O'Hare International Airport (ORD)
Airspace Case No. 2003-AGL-0848-NRA
Review of Draft Airport Layout Plan

**O'HARE
MODERNIZATION
PROGRAM**

**AERONAUTICAL STUDY
2003-AGL-0848-NRA**

Attachment 1

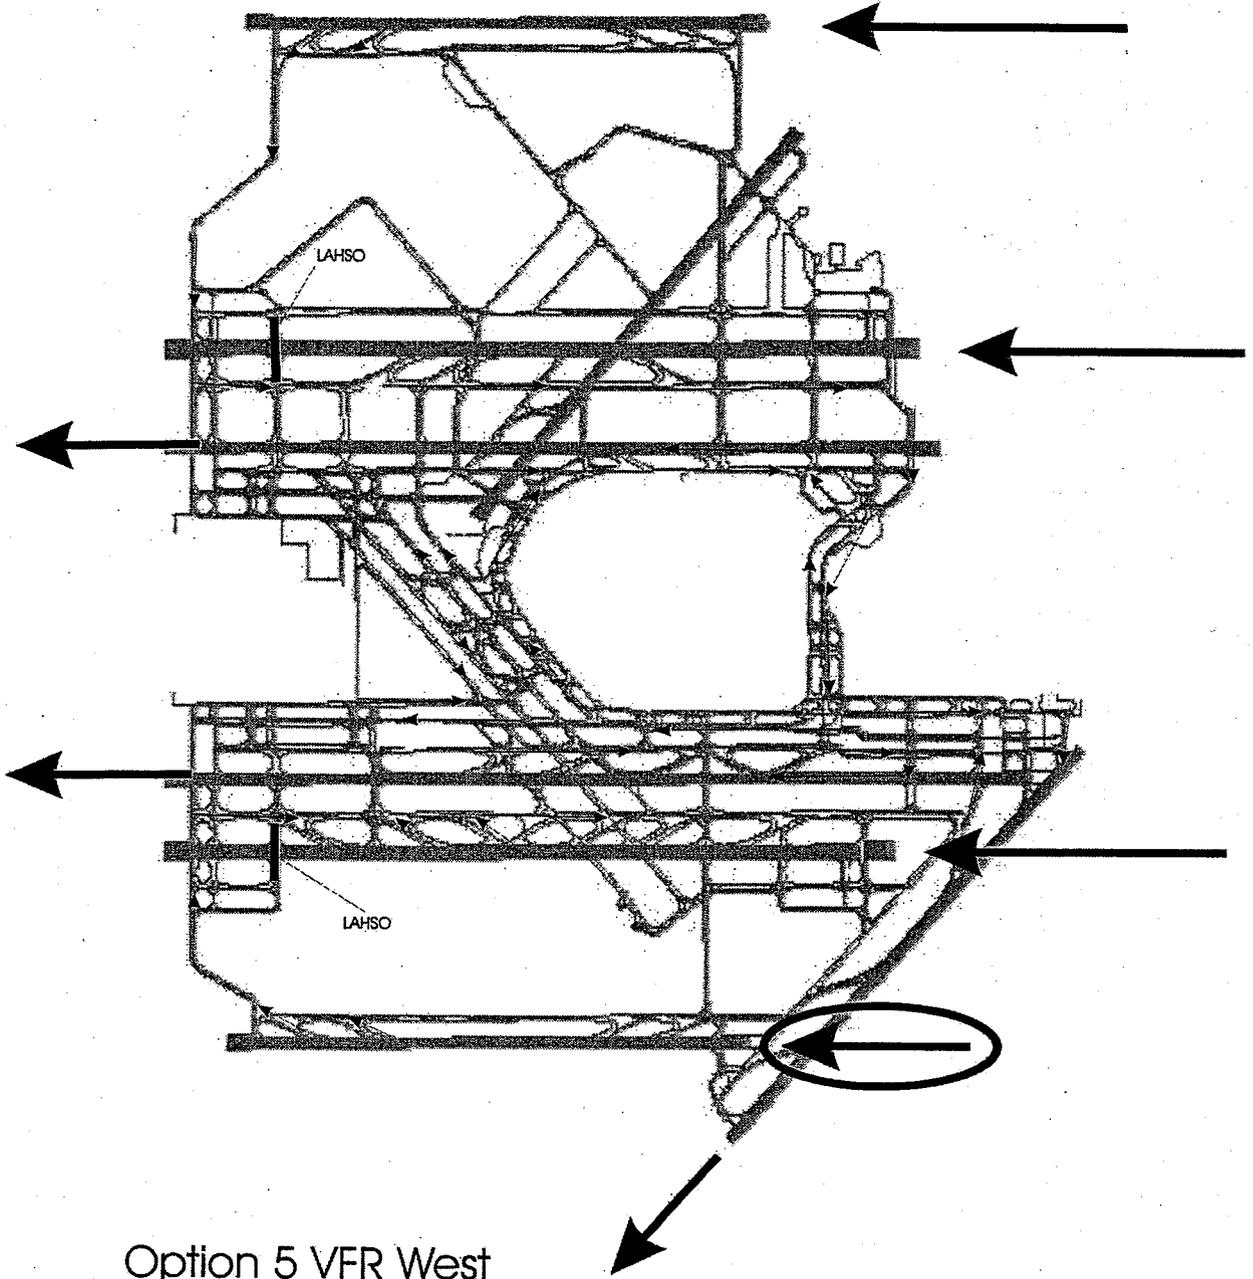
B-75. 5.5.1.2, 1st paragraph. Runway 4L departures are referenced. Complexity and workload issues have made the use of Rwy 4L on this configuration undesirable. Subsequent simulations conducted by the City have removed this runway and substituted Rwy 10R as a departure runway in this configuration. See Attachment 1.

B-76. 5.5.1.3, Exhibit V-31. Exhibit V-31 should be replaced with Attachment 1.

Attachment 2

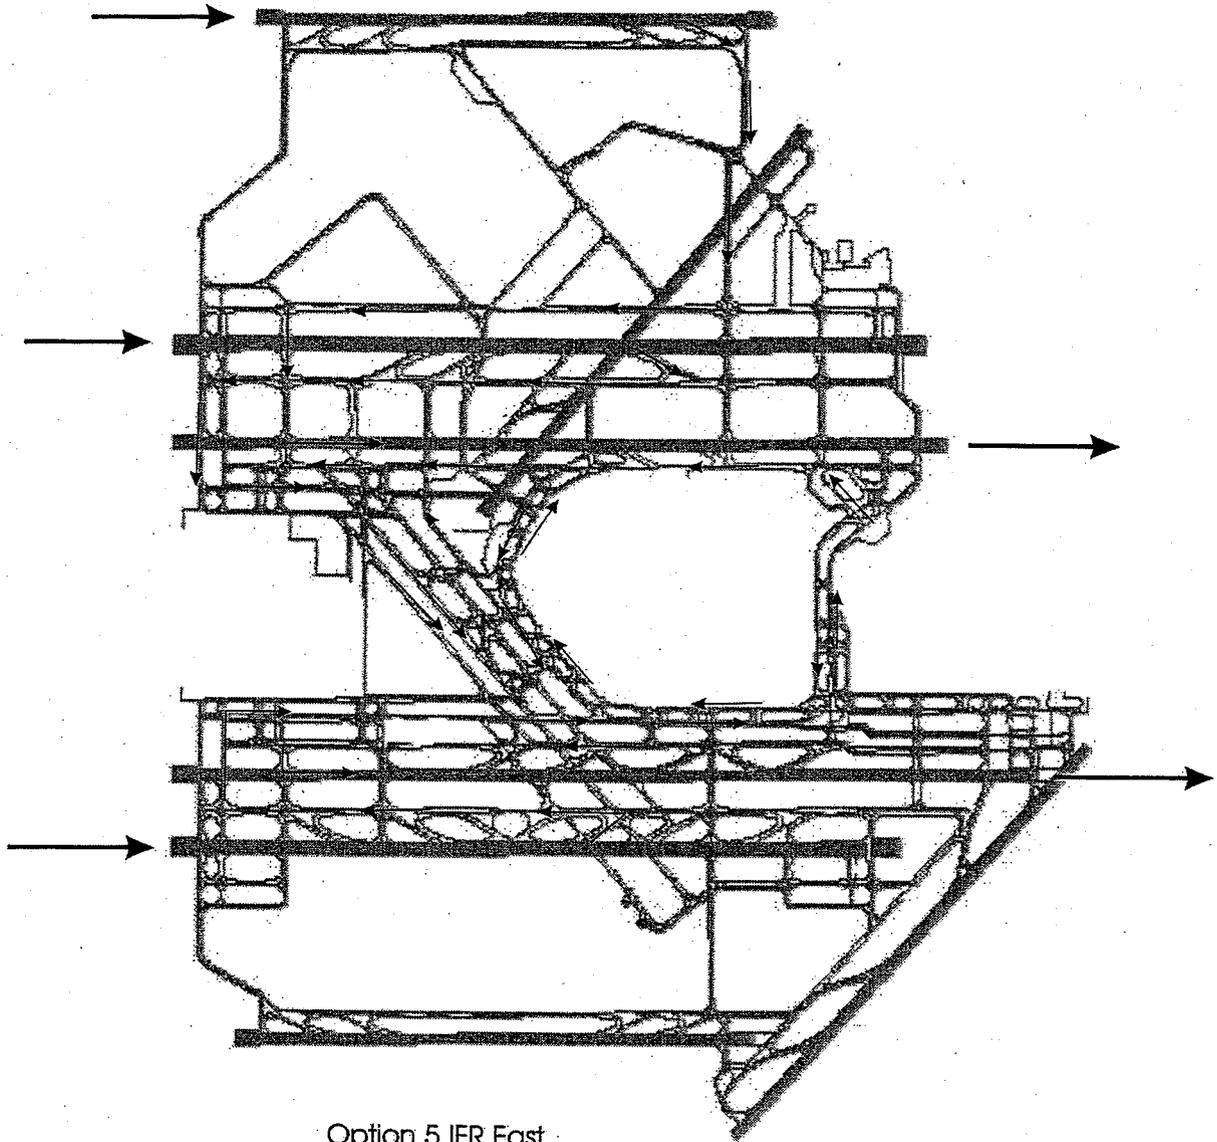
B-80. 5.5.2.2. See comment B-50. Departure runways are not correctly depicted. They are correctly depicted in Attachment 2.

B-81. 5.5.2.3. Exhibit V-33 should be replaced with Attachment 2.

Attachment 3

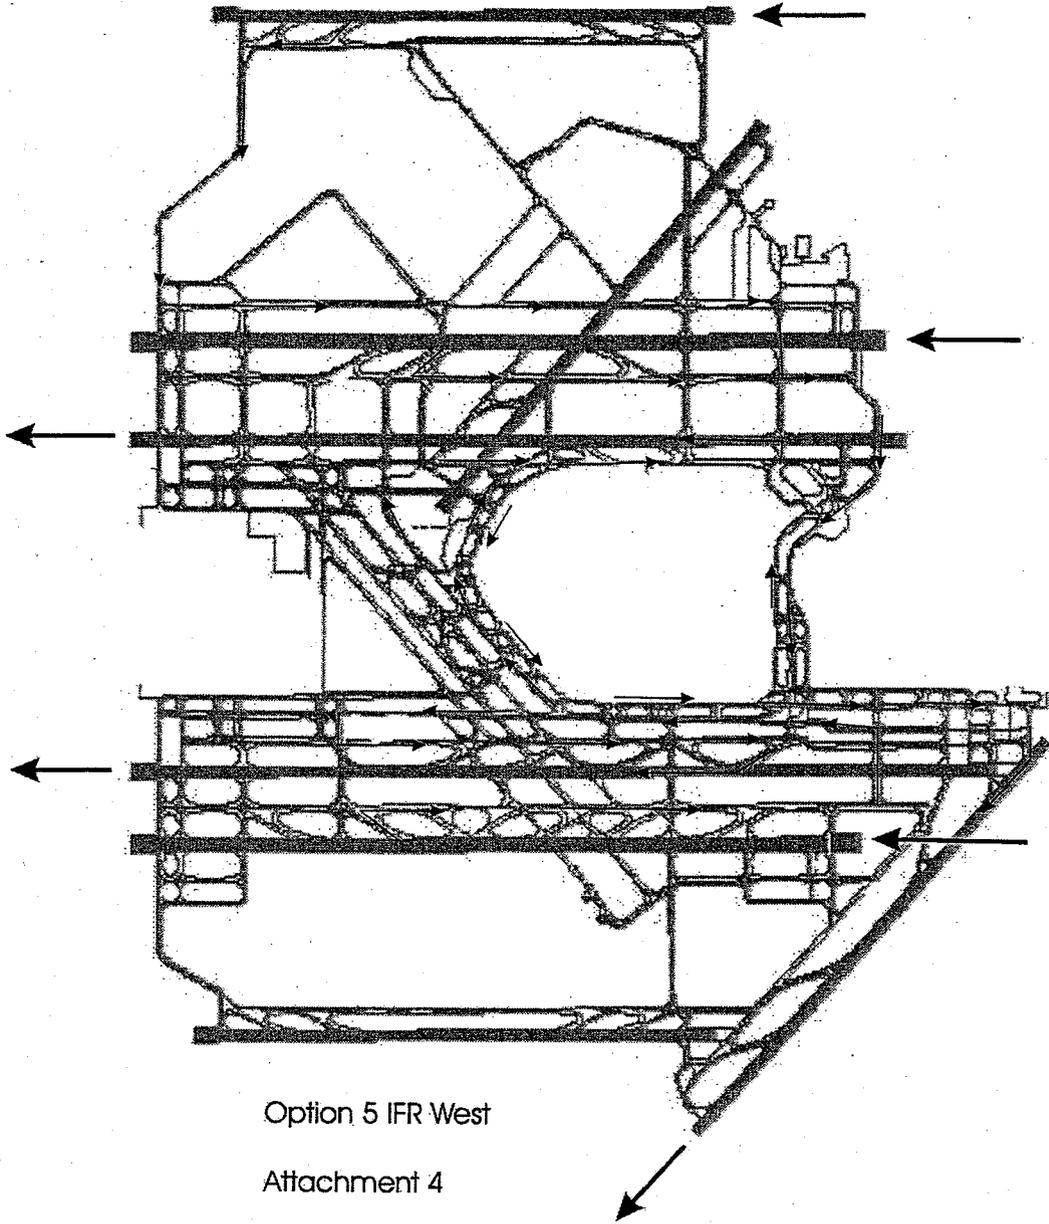
B-85. 5.5.3.3. Exhibit V-35 indicates Rwy 22L as a primary taxi route for Rwy 10R departures. The users and the Office of Runway Safety have voiced concerns about the use of runways as a primary taxi route. To mitigate this, Air Traffic has developed an alternate route, as depicted on Attachment 3. Exhibit V-35 should be replaced with Attachment 3.
